Project:	<b>Highways England Spatial Planning Arrangement</b>	Job No: <b>60600479</b> <b>DM014.008</b>
Subject:	<b>South Caldecotte, Audit of forecast VISSIM model</b>	
Prepared by:	<b>Alex Pina Botella</b>	Date: <b>09/01/2020</b>
Checked by:	<b>Javier Pardo</b>	Date: <b>13/01/2020</b>
Verified by:	<b>Phil Arnold and Liz Judson</b>	Date: <b>17/01/2020</b>
Approved by:	<b>John Alderman</b>	Date: <b>24/01/2020</b>

## Executive Summary

This Technical Note (TN06) provides a summary of the audit work conducted on the revised Forecast Vissim model developed for the A5 Kelly's Kitchen Roundabout by BWB. The Vissim model has been prepared to support the planning application of an employment development at South Caldecotte in Milton Keynes.

Figure 1. Distribution of new journey time observations across the peak hours.

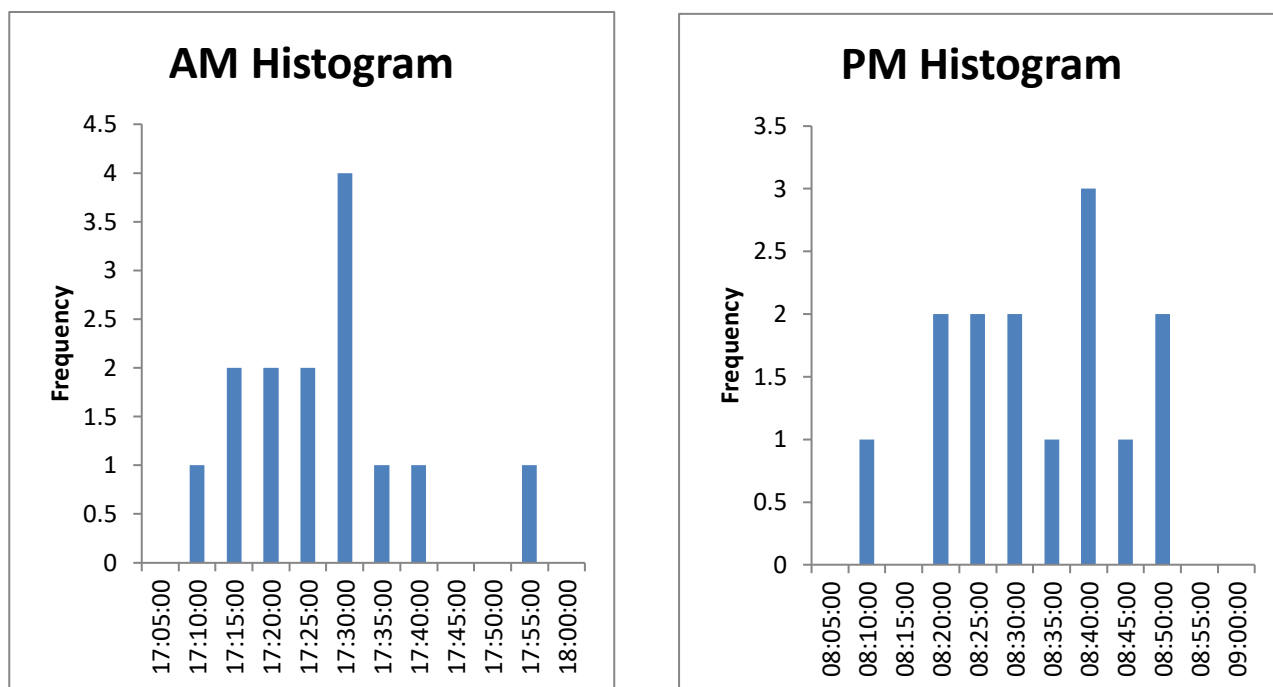
Figure 1 shows the distribution of the new observations within the corresponding peak hour, which seems appropriate.

**Figure 2. Incorrect lane allocation on the approach on Watling Street (top left) and on the conflicting arm inside the roundabout (bottom left). Scheme drawing indicating allowed movements from each lane (right).**

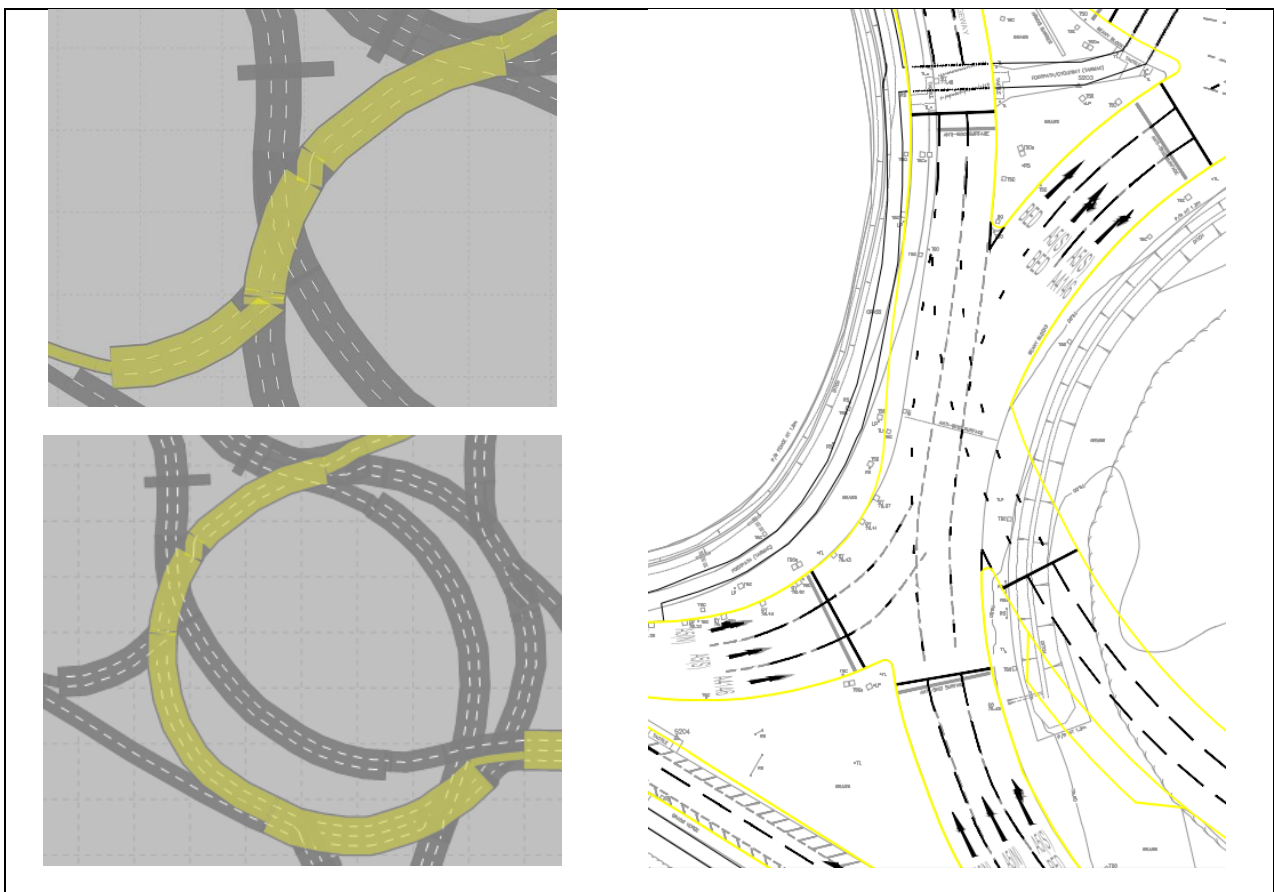
Figure 2 shows the movement from Watling Street to Brickhill Street, where vehicles are forced to join the junction using the middle lane or the offside lane and continue along the two offside lanes on the roundabout, using the routing connector to move to the two nearside lanes to access the exit onto Brickhill Street.

Based on the drawing of the committed intervention at this junction, the nearside lane on the Watling Street approach should accommodate the movements into the A5 northbound and into Brickhill Street, whilst in the Vissim model, it is dedicated for the left turn into the A5 northbound only.

Figure 2 also shows incorrect lane allocation on the northbound circulatory. Whilst the scheme drawings show that the right turn should only be allowed from the offside lane, the model allows the right run movement from the offside and middle lanes.

It is recommended that the model is coded so that movements from each lane accurately reflects the proposed lane allocation of the committed scheme. These issues are considered **MEDIUM**, as it is likely that the operation of the model with the correct lane allocation will result in different modelling results.

**Figure 3. Incorrect lane allocation on the approach on the A5 southbound.**

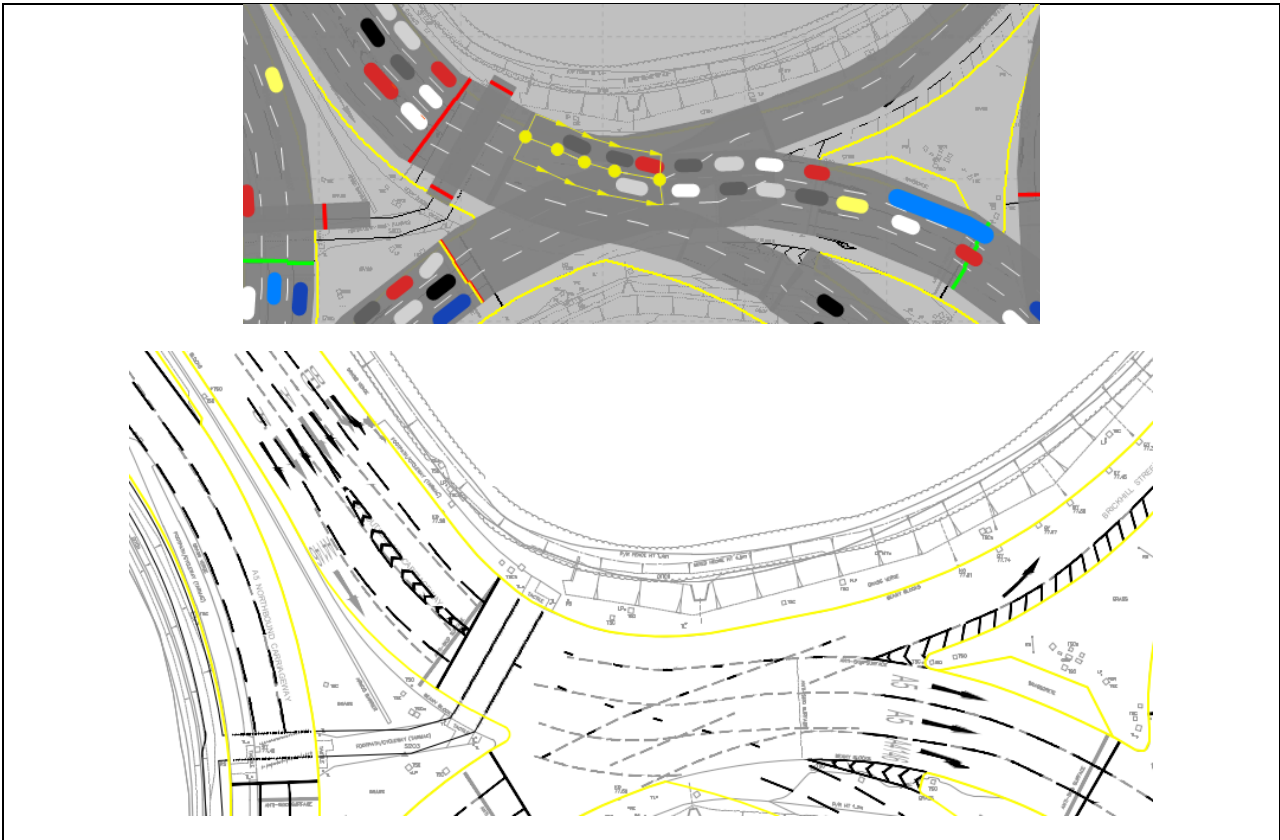
Figure 3 below shows incorrectly modelled lane allocation on the A5 southbound approach to the junction. According to the drawing, the nearside lane should be left turn only, whilst in the Vissim model, this lane is also used for the straight-ahead southbound movement.

Figure 4. Vehicles changing lanes over the hatched area and after the stop-line on the A5 southbound approach (left). Scheme drawing for this approach (right).

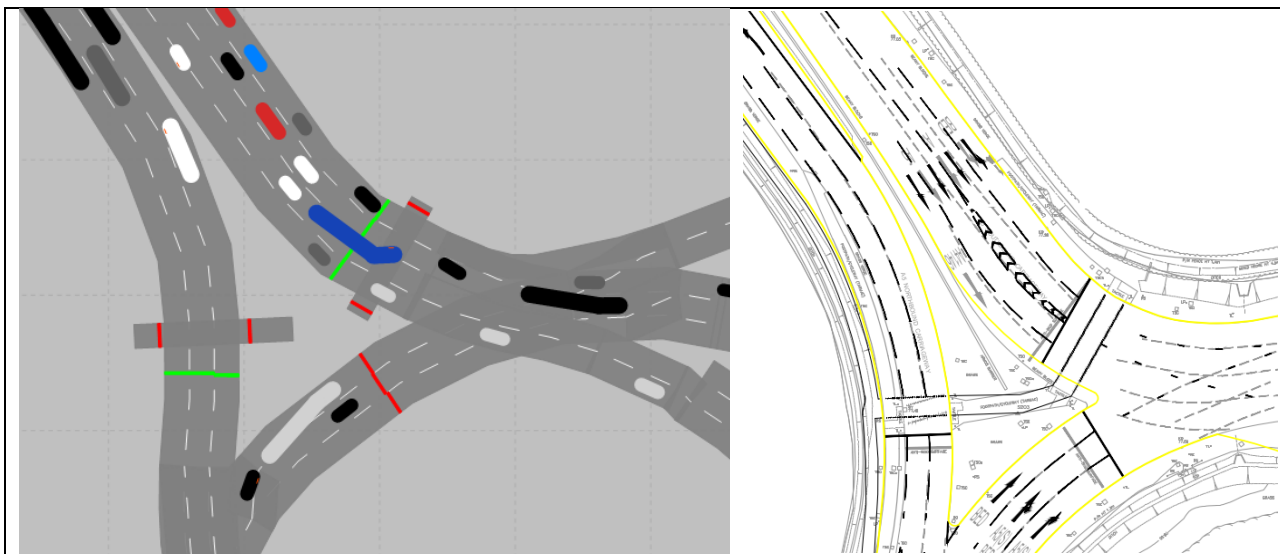
Figure 4 below shows an example of a large vehicle changing lanes after the stop-line and over the hatched area on the A5 southbound approach to the junction. This lane change should be banned in the length of hatched area shown in the scheme drawing and should not be allowed after the stop-line either.

Given the number of vehicles changing lanes over the hatched central reservation, this issue is likely to have a noticeable impact on modelling results. **MEDIUM.**

Lane changes in the model over the hatched area should not be permitted, it is recommended that this issue is solved by increasing the lane change emergency stop distance of the downstream connectors.

Figure 5. Lane changes are allowed in Vissim over the hatched area on the A5 northbound approach to the junction (left). Scheme drawing of this approach (right).

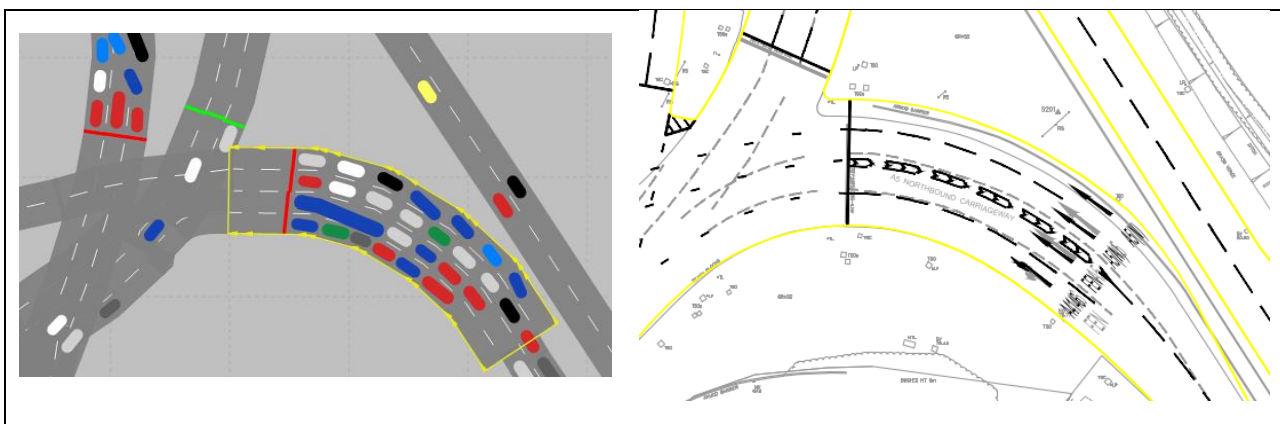
Figure 5 below shows the same issue on the A5 northbound approach to the junction, where lane changes over the central hatched area are allowed in the Vissim model. However; given the lane change distance parameters of the downstream connectors, all vehicles reach this area in their desired lanes and no vehicles have been observed making lane changes over the hatched area, therefore it is not considered an issue. It is however recommended that this lane change over the hatched area is not permitted in the model.

**Figure 6. Crashing vehicles at the southern stream of the roundabout.**

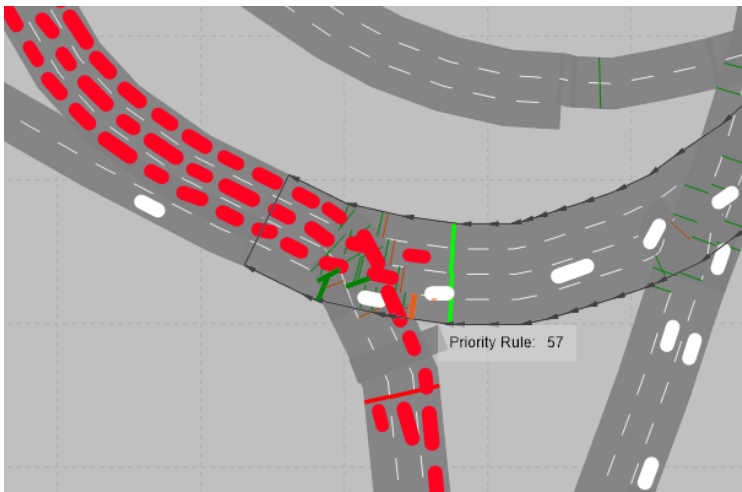
Priority rule 57 (shown in Figure 6) does not have a priority marker at the offside lane of the A4146 northbound approach to the roundabout, resulting in vehicles travelling to Watling Street ignoring the queuing vehicles inside the roundabout and overestimating the capacity of this movement.

Given the frequency with which it occurs, and the number of vehicles running over queuing traffic inside the roundabout, this issue is considered **MEDIUM**.

It is recommended that priority rules are coded so that queuing traffic effectively blocks the lanes it is occupying (using a priority rule with a headway as a parameter), or that yellow box behaviour is coded in the conflict area to prevent queuing vehicles blocking the movement.

Figure 7. Location of controller 1, signal group 3.

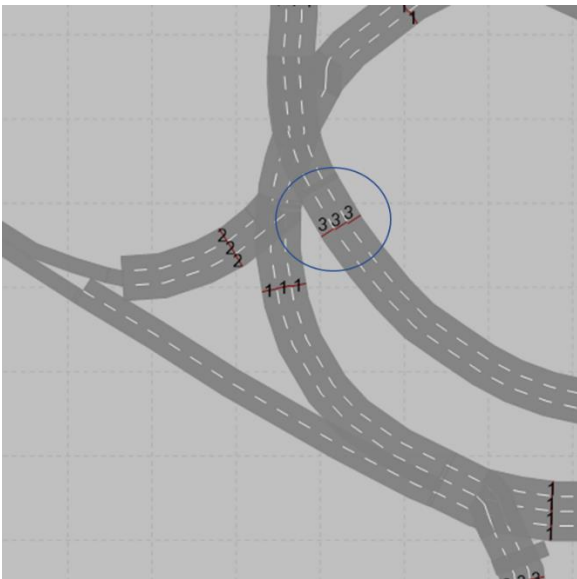
There is a significant increase (from 10 to 25 seconds) in the maximum green time of the Signal Group 3 in Controller 1 (indicated in Figure 7). This increase only affects the PM “with development” (Scenarios 2 and 4) and “with development + committed scheme” (Scenarios 5 and 6) scenarios. It is expected that the signal timings change significantly with the addition of development traffic, however, it is recommended that any substantial modification in the signal controllers between scenarios is appropriately justified.

Figure 8. Excessive queuing inside the roundabout.

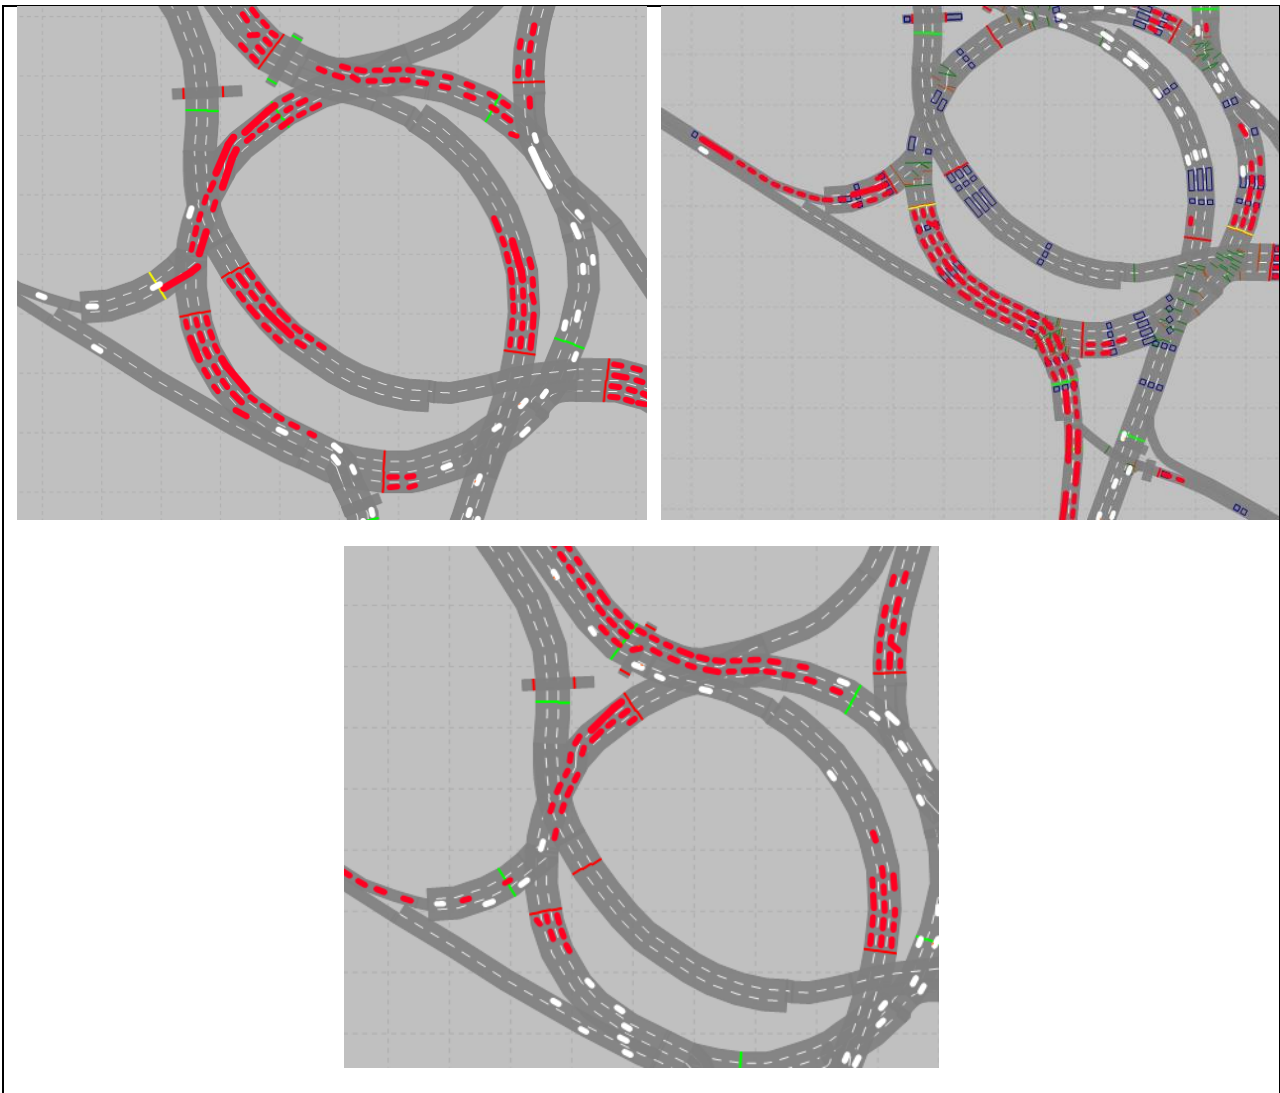
The signal coding of the committed scheme at Kelly’s Kitchen roundabout results in excessive queuing inside the roundabout that often builds back and blocks upstream conflict points (Figure 8).

Arms discharging traffic into the roundabout often get right of way, so that traffic enters the roundabout to join the back of a queue at the downstream signals, as shown in Figure 8 (bottom).

The modelled signal operation is not realistic and overestimates the capacity of the junction – since timings would likely limit queuing on the roundabout circulatory links due to safety considerations. Resolving this issue may increase delays on approaches to the roundabout operation increasing the impact of the development traffic. This issue is considered **MEDIUM**.

Queues inside the roundabout should mostly remain within 2/3 of the corresponding link’s length, with the feeding signals changing to red when this limit is reached.

It is recommended that the signals are coded so that queues inside the junction remains within approximately 2/3 of the length of the internal links, and that downstream queues have started clearing when upstream signals change to green.

Figure 9. PM Network performance results for overall delay and average speed produced by the submitted model.

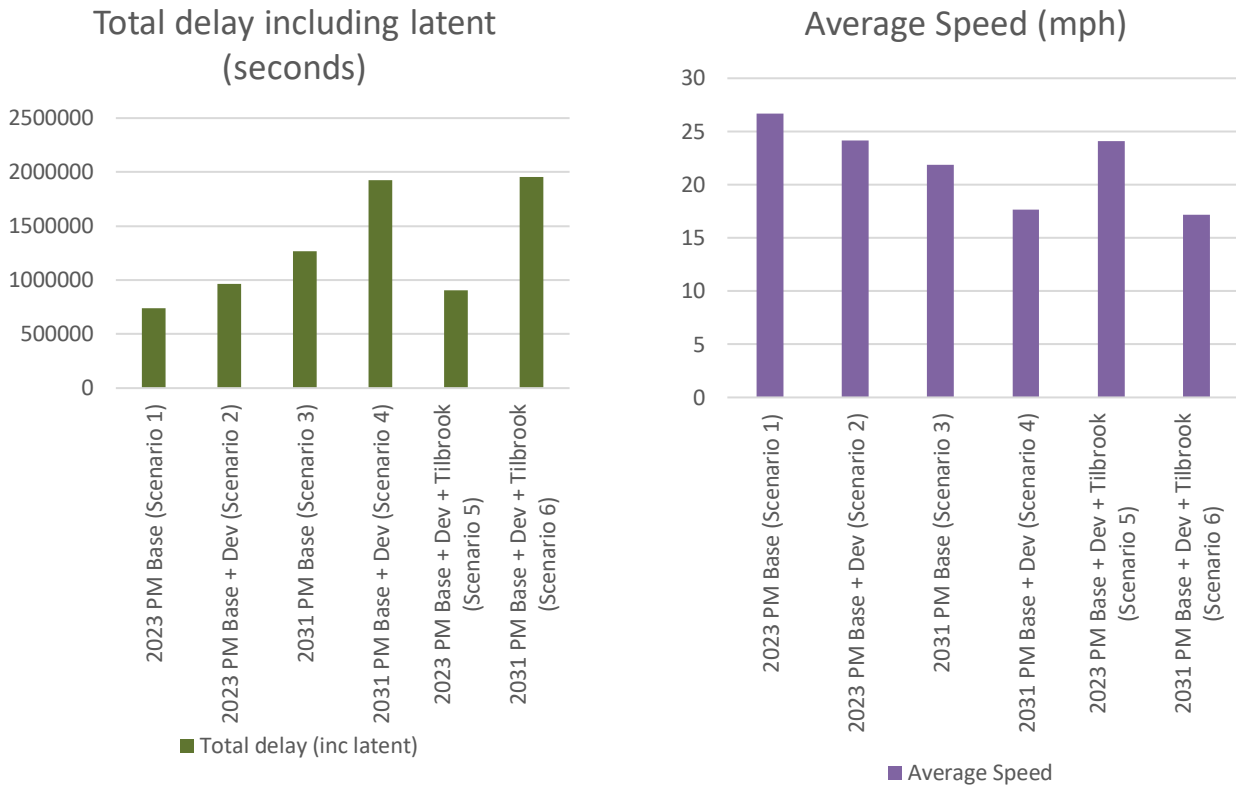
Figure 9 shows the network performance delay results of all PM forecast models (all delay including latent delay) and average speed.

The analysis of PM journey time results in Table 4, and the network performance results shown in Figure 9, indicate that the proposed development would have a substantial impact on committed Kelly’s Kitchen Roundabout scheme, which the committed Tilbrook Roundabout scheme does not offset, indeed, for the 2031 assessment, the Tilbrook Scheme is shown to exacerbate some the issues identified.
